## Committee of the Whole Report For the Meeting of October 17, 2024

**Subject:** **Rezoning Application No. 00862 and Development Permit with Variance No. 00252 for 2002 Richmond Road, 1903/1909 Birch Street, and 1769 Pembroke Street**

**Figure 3: Option B – Plaza**

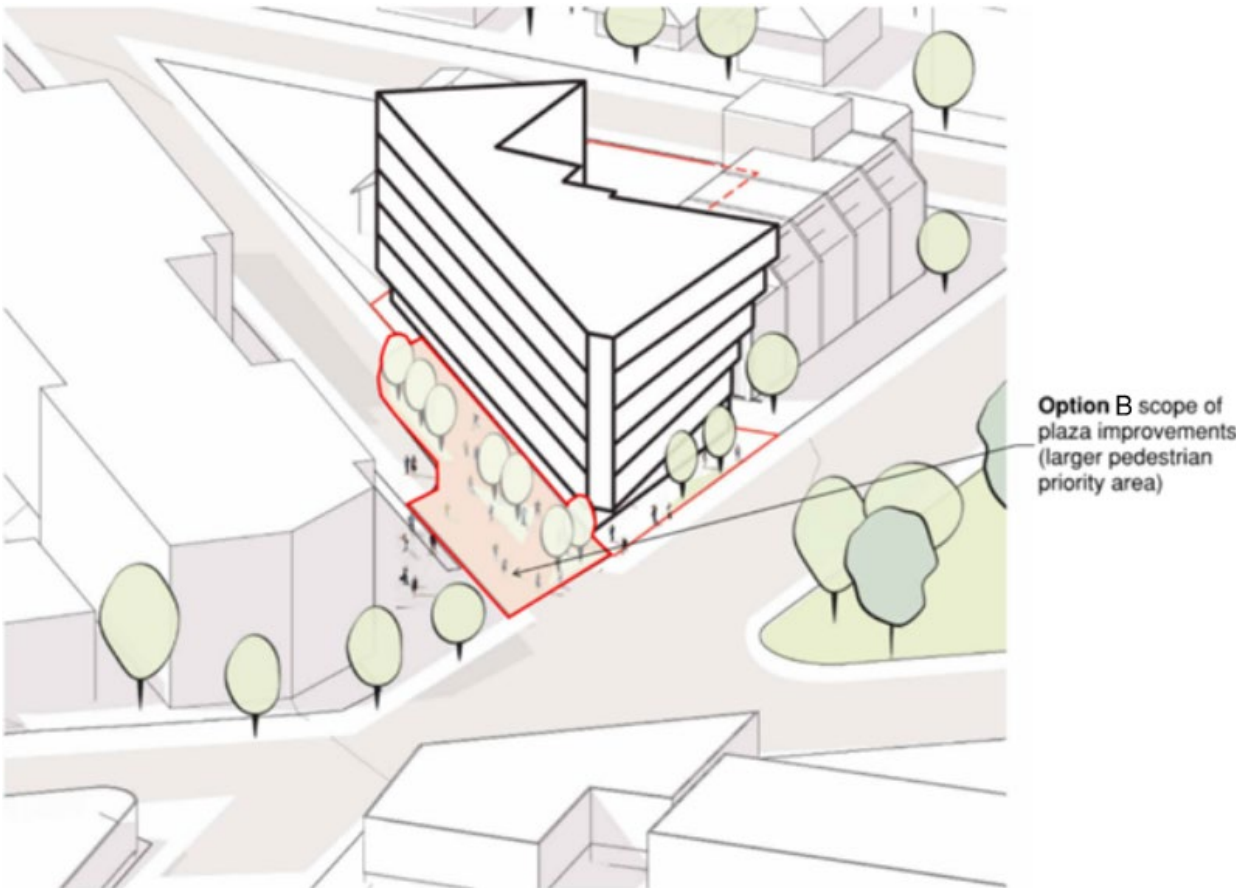
- Option B – Full Plaza (recommended): Birch Street frontage works are built in partnership with the City. Plaza improvements would extend beyond centreline and tie into the existing curb on the south side of Birch Street. Plaza improvements would be designed and constructed by the applicant to the satisfaction of the Director of Engineering, with funding provided by the City. Construction of the plaza would require the closure of that portion of Birch Street, as identified in plans dated May 2, 2024, to all traffic except emergency vehicle, bicycle, and pedestrian access.

The closure of Birch Street, though off-site and City property, would greatly improve the open space area available to residents of the building as well as patrons of the commercial retail units. The build out of the plaza, as designed by the applicant, would allow the greatest utilization of the closure area by not only residents of the building but all pedestrians as a space to gather and socialize. The plaza area would also allow for greater tree planting area and achieve greater canopy cover and landscaping.
